CALL NO. 200
CONTRACT ID NO.
131212 Addendum # 2

Subject: Marshall Trigg County, 121GR13D012 - NHPP 0801 (098)
Letting December 20, 2013

- (1) Revised - Plan Sheets - R2, S2, S134, S183, S184A, S184B, S187, S192, S194, S206, S207, S207A, S207B, S208, S208A, S208B, S209, S209A, S210, S211, S212, S213, S216, S217, S260, S261, S274
- (2) Revised - Cover Page - PAGE 1 of 403
- (3) Revised - Completion Dates - Page 4 of 403
- (4) Revised - Multiple Notes - Various Pages
- (5) Revised - Bid Items - Page 397-403 of 403
- (6) Delete - Pages 27thru44, 216thru233, 207thru215, 234thru238 of 403

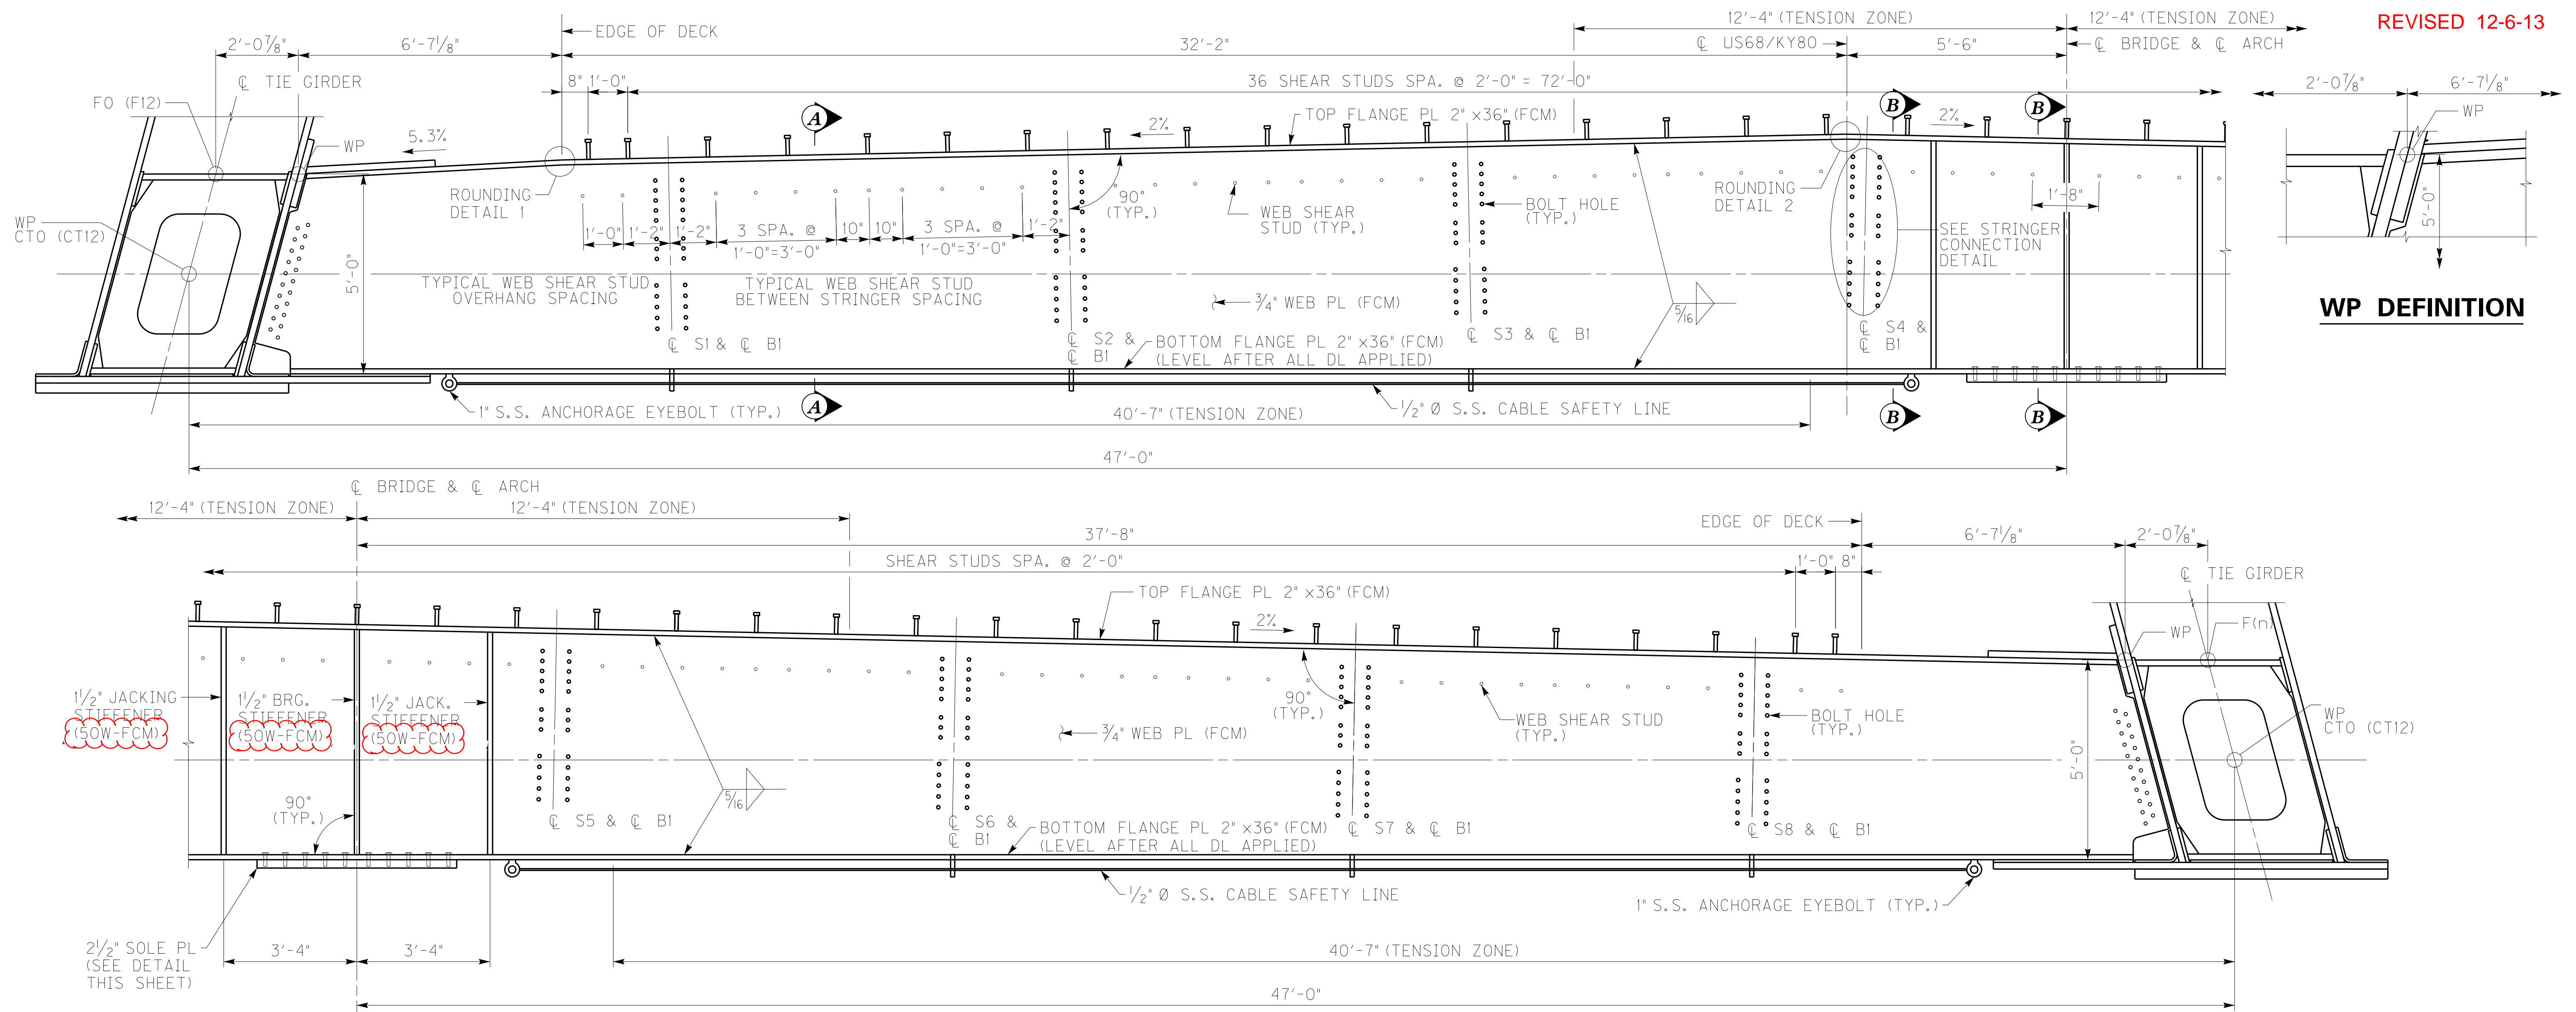
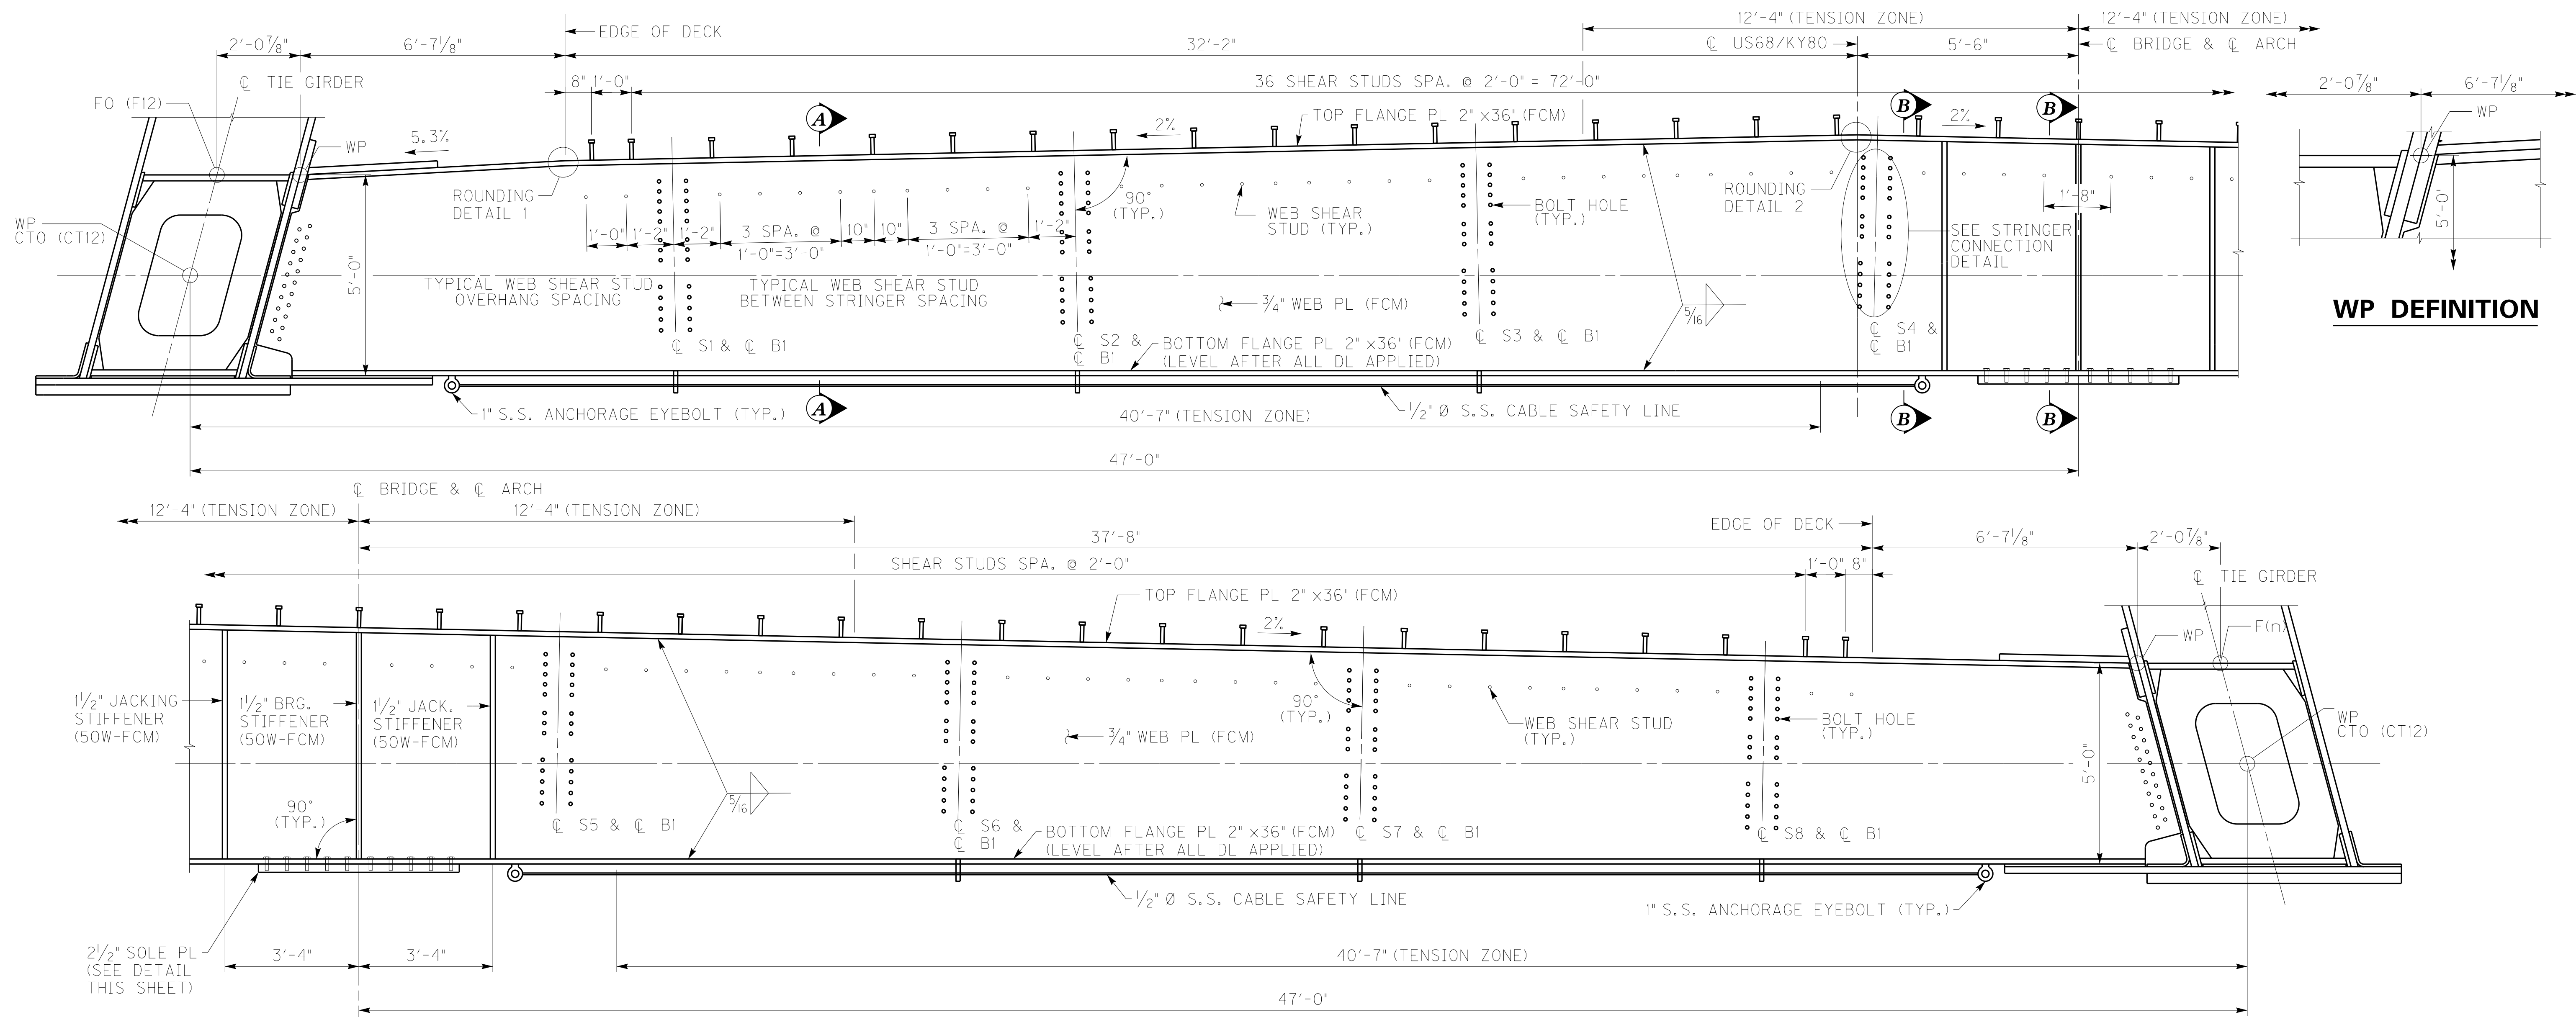
ADD FCM TO STIFFENERS, ADD NOTE 10		11/25/13
REVISION		DATE
DATE: NOVEMBER 15, 2013	CHECKED BY	
DESIGNED BY: JCS	RMS	
DETAILED BY: MJD	JCS/ACK	
Commonwealth of Kentucky DEPARTMENT OF HIGHWAYS		
COUNTY MARSHALL / TRIGG		
ROUTE US68	CROSSING KENTUCKY LAKE	
END FLOORBEAM		
PREPARED BY		SHEET NO.
MICHAEL BAKER JR., INC. 9750 ORMSBY STATION ROAD SUITE 210 LOUISVILLE, KY 40223		S187
Baker		DRAWING NO. 24686
